Serial: RA-21-0183  
April 28, 2022

H. B. ROBINSON STEAM ELECTRIC PLANT, UNIT NO. 2  
DOCKET NO. 50-261 / RENEWED LICENSE NO. DPR-23

**SUBJECT: Remove 4.160 kilovolt Bus 2 from Surveillance Requirement 3.8.1.16  
(Automatic Transfer Capability from Unit Auxiliary Transformer to Startup  
Transformer)**

ONE LINE DIAGRAM  
 UNIT 2 AUXILIARY DISTRIBUTION SYSTEM  
 FIGURE 8.1.2-1A REVISION NO. 28

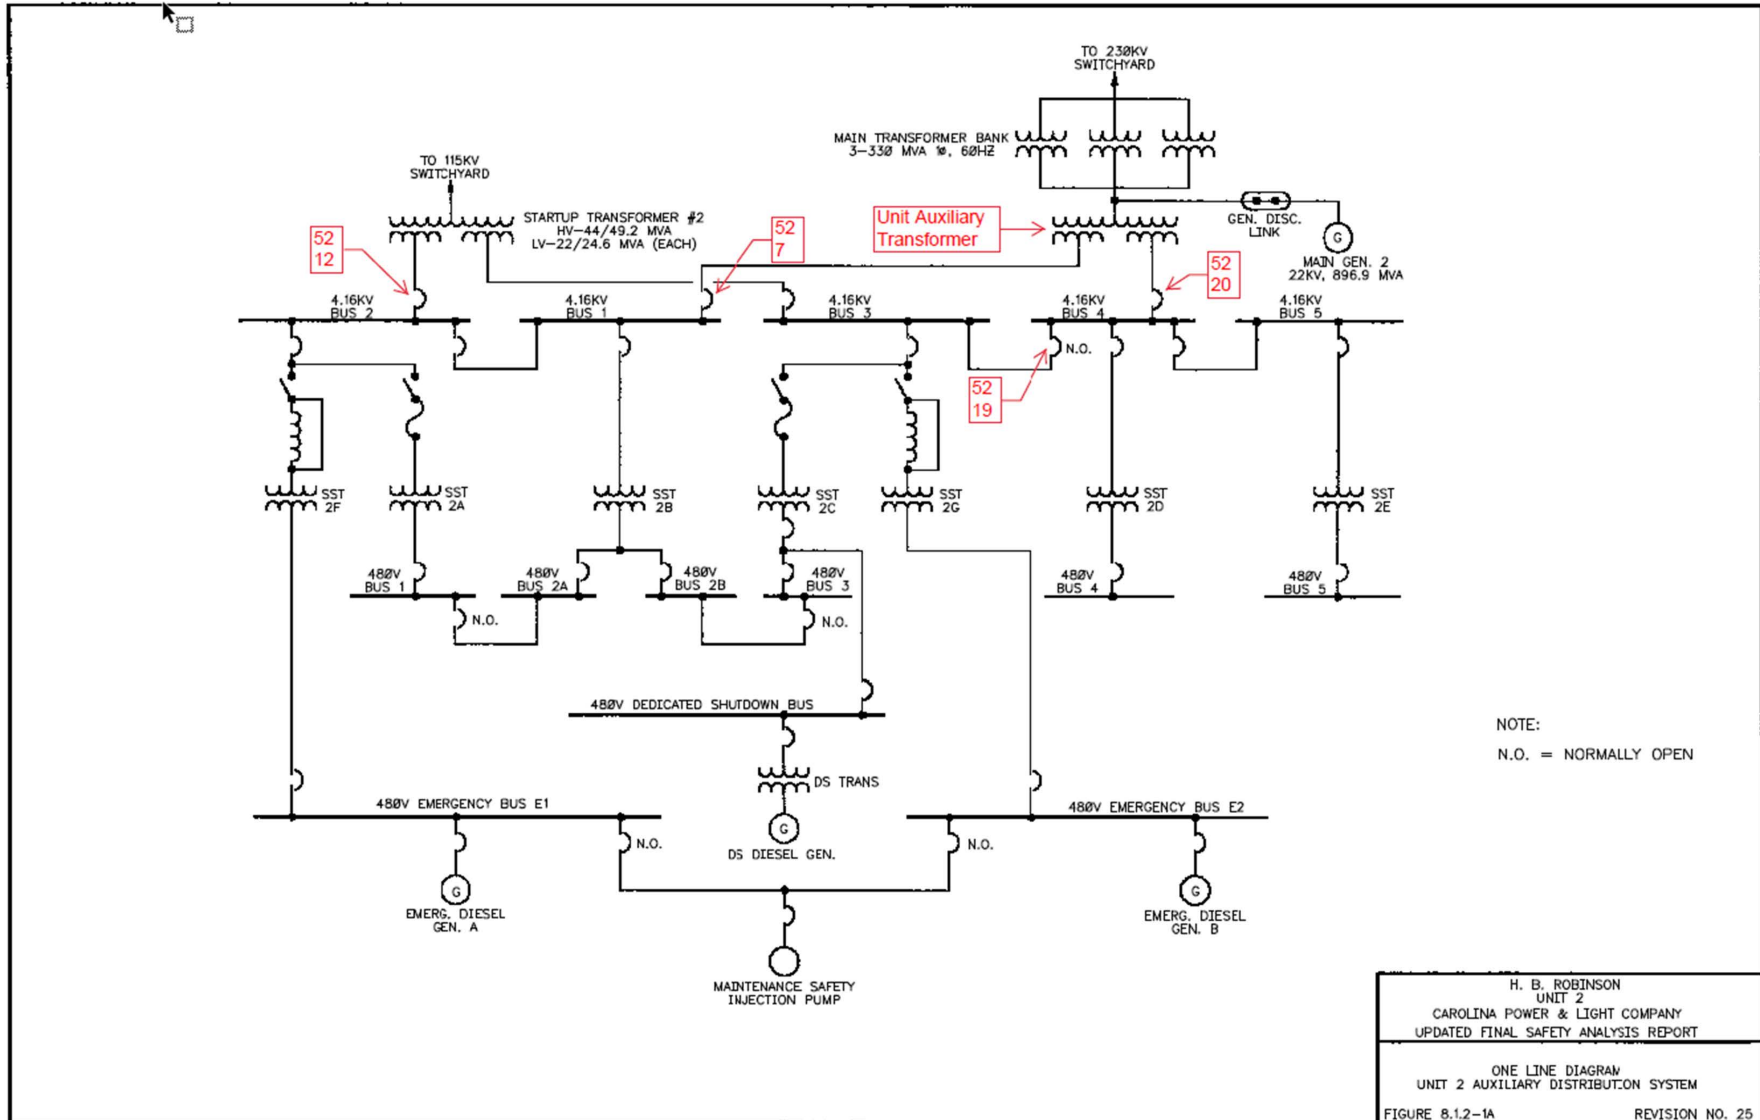
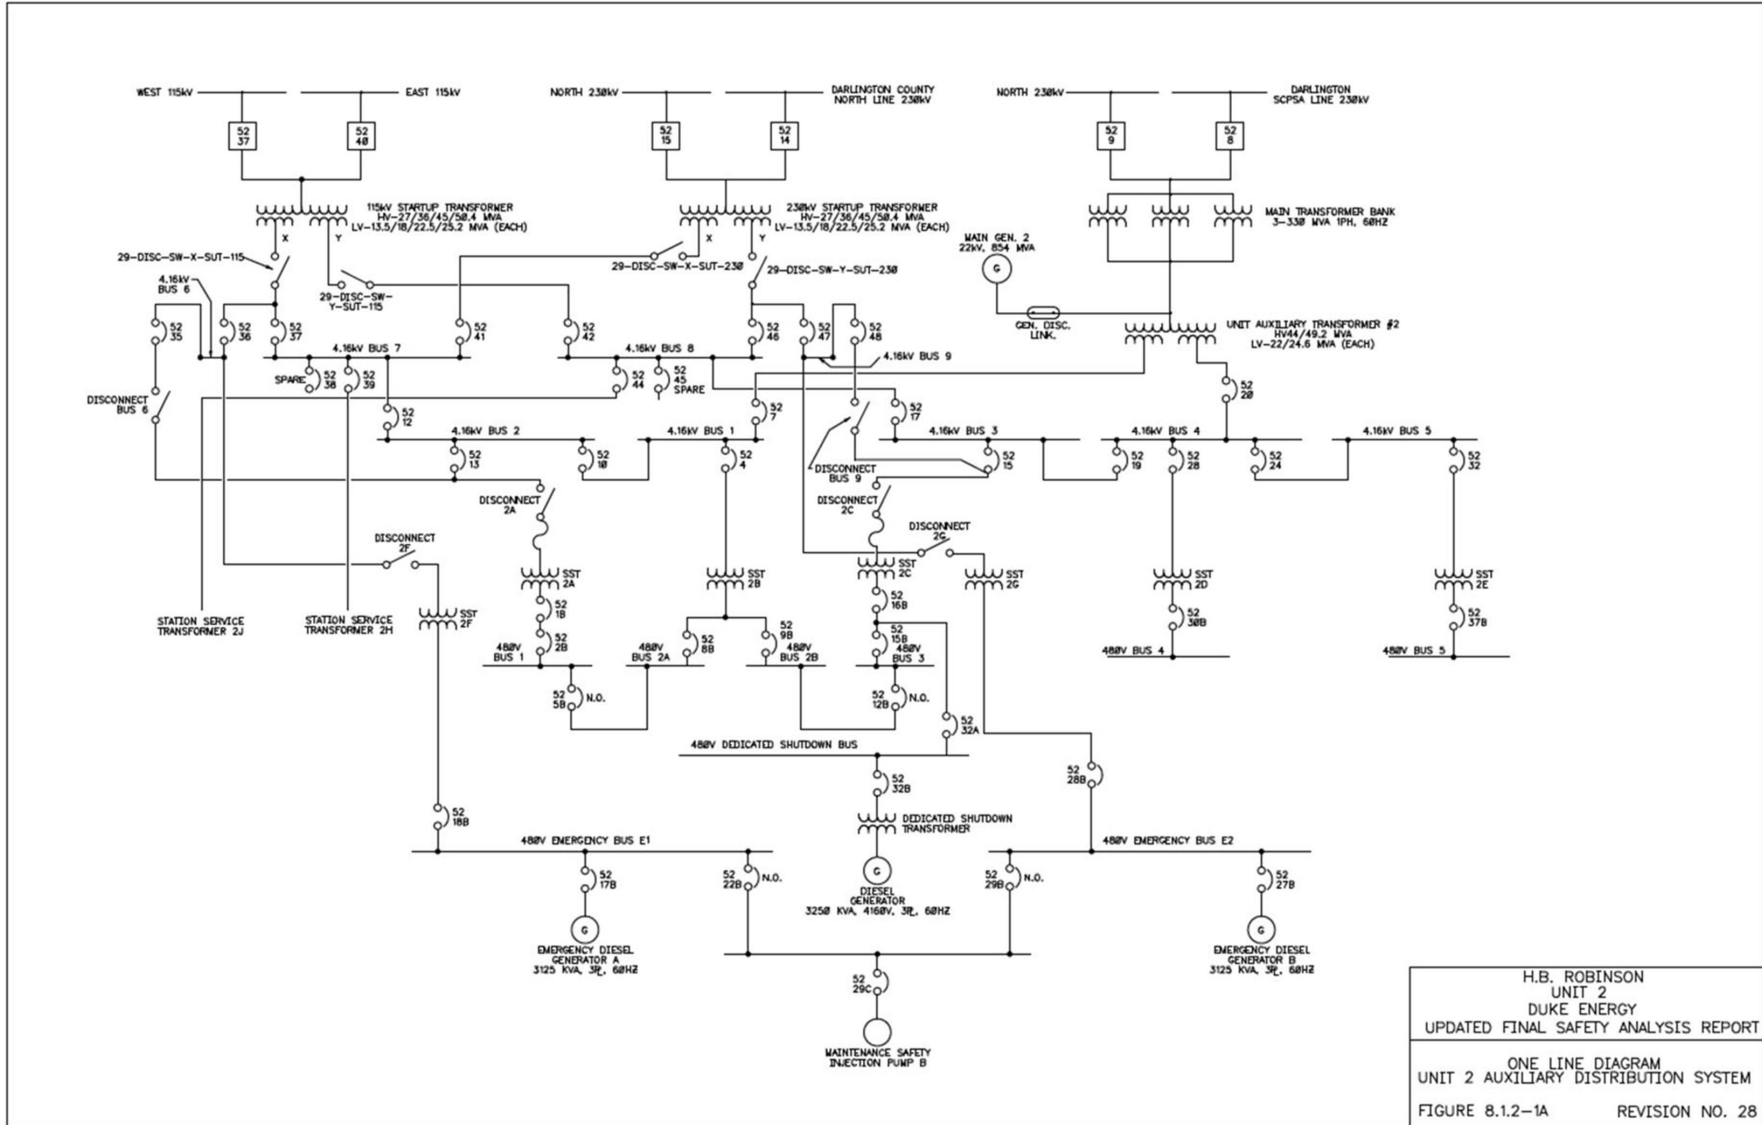
TS Amendment 261 (Reference 2), issued on September 10, 2018, added a second qualified offsite power circuit via a new 230 kV SUT as well as four new 4.160 kV buses (buses 6, 7, 8, and 9). RNP UFSAR Figure 8.1.2-1A, “One Line Diagram Unit 2 Auxiliary Distribution System,” is shown on the following pages, both before and after TS Amendment 261. As shown on the first figure depicting the electrical configuration prior to TS Amendment 261, the direct feed of 4.160 kV power to 480 V Emergency bus 1 was 4.160 kV bus 2, such that power to 480 V Emergency bus 1 would always flow through 4.160 kV bus 2. Therefore, inclusion of 4.160 kV bus 2 in SR 3.8.1.16 did not create an issue prior to Amendment 261; if 480 V Emergency bus 1 incurred an automatic transfer from the UAT to SUT, this would have included an automatic transfer of 4.160 kV bus 2 from the UAT to SUT. As a result of TS Amendment 261, the direct feed of 4.160 kV power to 480 V Emergency bus 1 was changed from 4.160 kV bus 2 to 4.160 kV bus 6. The required safety related loads that must have power available to them for the qualified offsite circuits to be considered operable and for the LCO to be met are supplied by the ESF buses. SR 3.8.1.16 is specifically associated with ESF bus E1 (i.e., 480 V Emergency bus 1). In order to focus the SR 3.8.1.16 on the required loads to ensure that the LCO is met (i.e., the purpose of SRs), this amendment request proposes to remove 4.160 kV bus 2, rather than replace it with 4.160 kV bus 6. This will result in TS that continue to protect the health and safety of the public per the provisions of 10 CFR 50.36 for content of TS.
